Access Compliance Report

Public Rights-of-Way

(Curb Ramps)

Intersection ID: 21061	Main Street: SARDIS_RD	Cross Street: SMITHFIELD_DR	Location: SE
ADA ID: EDC65CF69E59	Ramp Type: PerpDiag	Initial Pass/Fail: Fail	Overall Compliance: No
Severity Score: 22.5			
Codes/Mitigation Info/Possible Solution		Field Measurements/Component Compliance

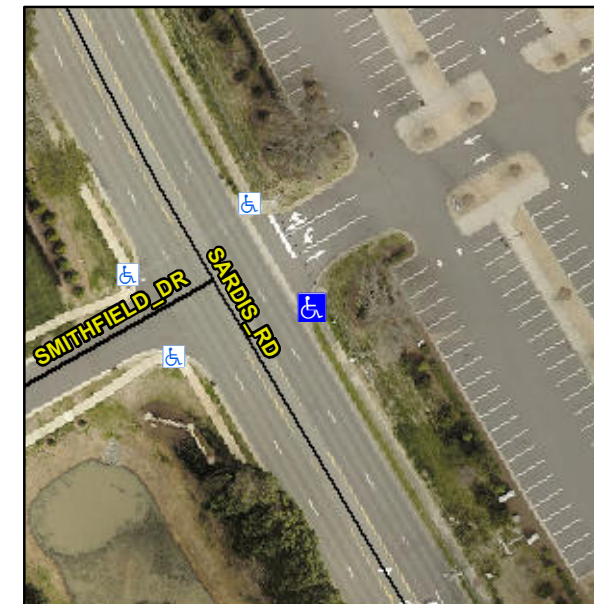
Not Found, R304.5.1, R304.2.2, R304.5.3

Compliance	Description	Data	Compliance	Description	Data
N/A	Ramp Length (in)	56.0	No	Ramp Slope (%)	8.6
No	Ramp Width (in)	46.0	No	Ramp XSlope (%)	2.9
N/A	Flare Type LT	N/A	N/A	Flare Type RT	N/A
N/A	Flare Slope LT (%)	N/A	N/A	Flare Slope RT (%)	N/A
N/A	Flare Traversable LT?	N/A	N/A	Flare Traversable RT?	N/A
N/A	Landing Length (in)	N/A	N/A	DWS Provided?	N/A
N/A	Landing Width (in)	N/A	N/A	DWS Contrast?	N/A
N/A	Landing Slope (%)	N/A	N/A	DWS Length (in)	N/A
N/A	Landing X Slope (%)	N/A	N/A	DWS Full Width?	N/A
N/A	Landing Curb? (Y/N)	N/A	N/A	DWS Offset (in)	N/A
N/A	Shared Landing?	N/A			
N/A	Gutter Ponding?	N/A	N/A	Gutter Slope (%)	N/A
N/A	Gutter Lip Ht (in)	N/A	N/A	Gutter X Slope (%)	N/A
N/A	Painted X Walk1?	No	N/A	Painted X Walk2?	No
	X Walk 1 Direction	To N		X Walk 2 Direction	To W
N/A	X Walk 1 Width (in)	N/A	N/A	X Walk 2 Width (in)	N/A
	X Walk 1 Slope (%)	0.2		X Walk 2 Slope (%)	4.8
	X Walk 1 X Slope (%)	1.6		X Walk 2 X Slope (%)	4.1

Remove & Replace Curb Ramp With Two New Directional Ramps or Equivalent.
